## PRODUCT BULLETIN # 16799

**TITLE:** Announcement of change in tape pocket dimension for NCV2901CTR

**NEW POCKET DIMENSION**

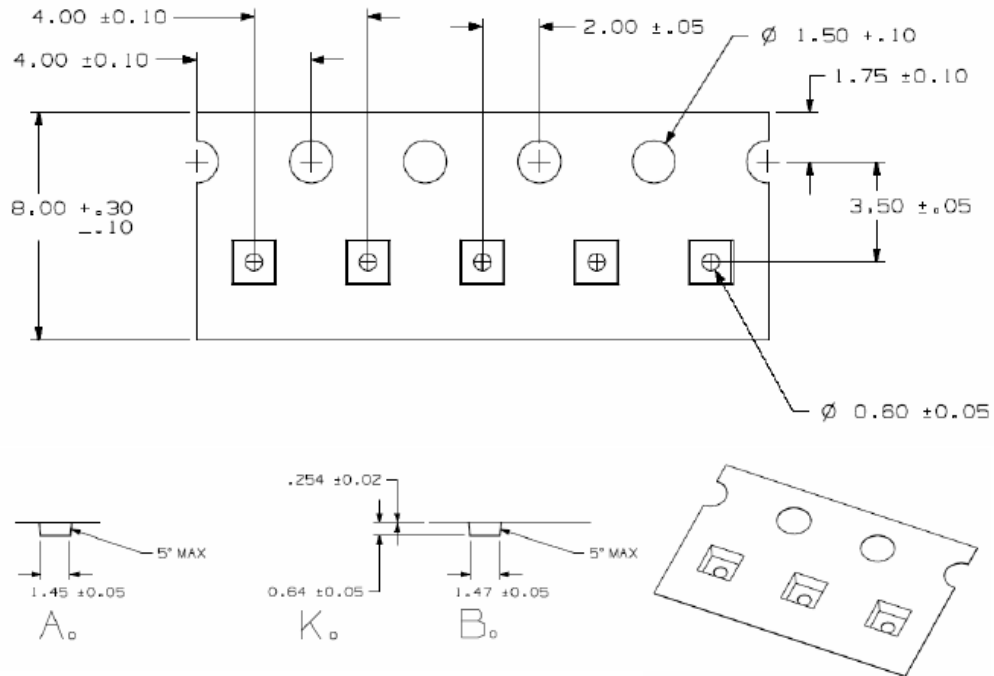
In order to prevent die from rotation (twisting) in the carrier tape pockets, a change in dimension of the tape pocket will be made as demonstrated below. There is no change in tape material or supplier, only a change in the pocket dimension.

Maximum Rotation Angle	Maximum Lateral Movement
OLD POCKET DIMENSION	23 degree	0.380mm
NEW POCKET DIMENSION	10.5 degree	0.200mm
EIA	<20 degree	<0.500mm
